Premier House
Manchester, UK —

Sustainable Drainage Strategy

FOR / Civil and Structural Engineering Services
CLIENT / Property Alliance Group REV / DRAFT DATE / 16 June 2021
PROJECT NO / L20081

Drawing Number: Aqua -

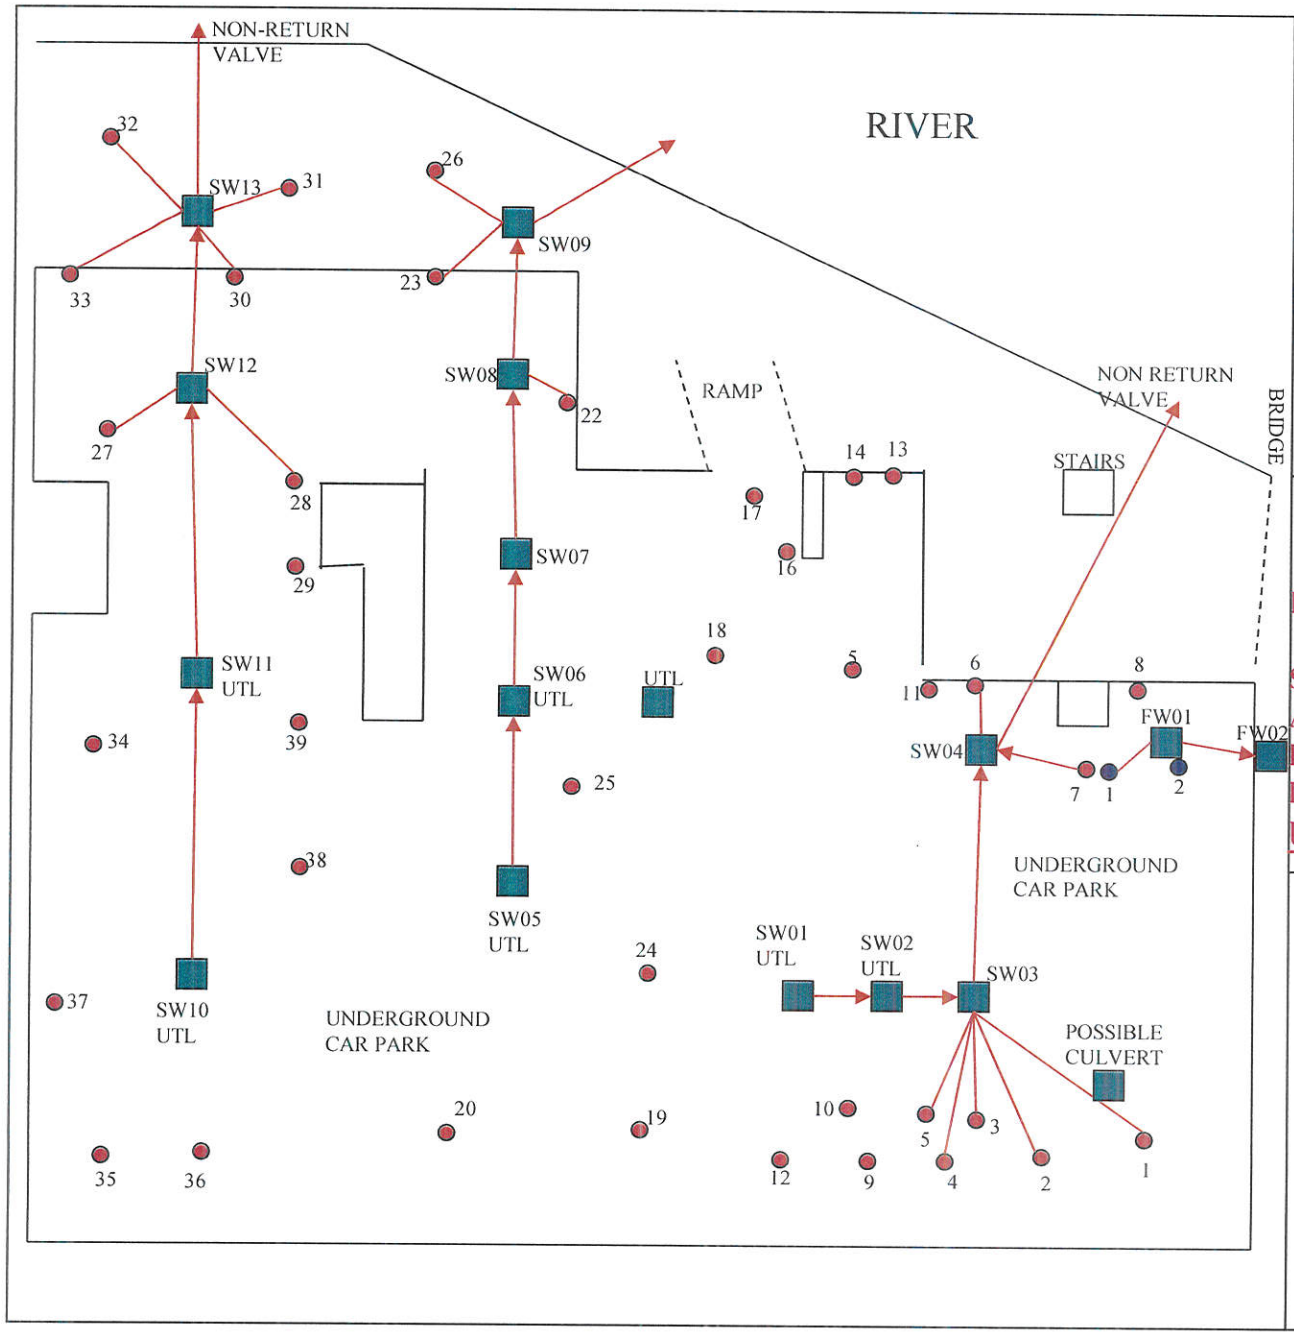
BG&E Markup
SR
19.04.21

Were these chambers buried?

Was this manhole lifted?

Was this manhole lifted?

Was the public sewer along Deansgate surveyed?

We believe there is drainage in the vaults, under the ramp. Was this within your scope of work and do you have any photographs of this area?

Why does the trace end here?

Why does the trace end here?
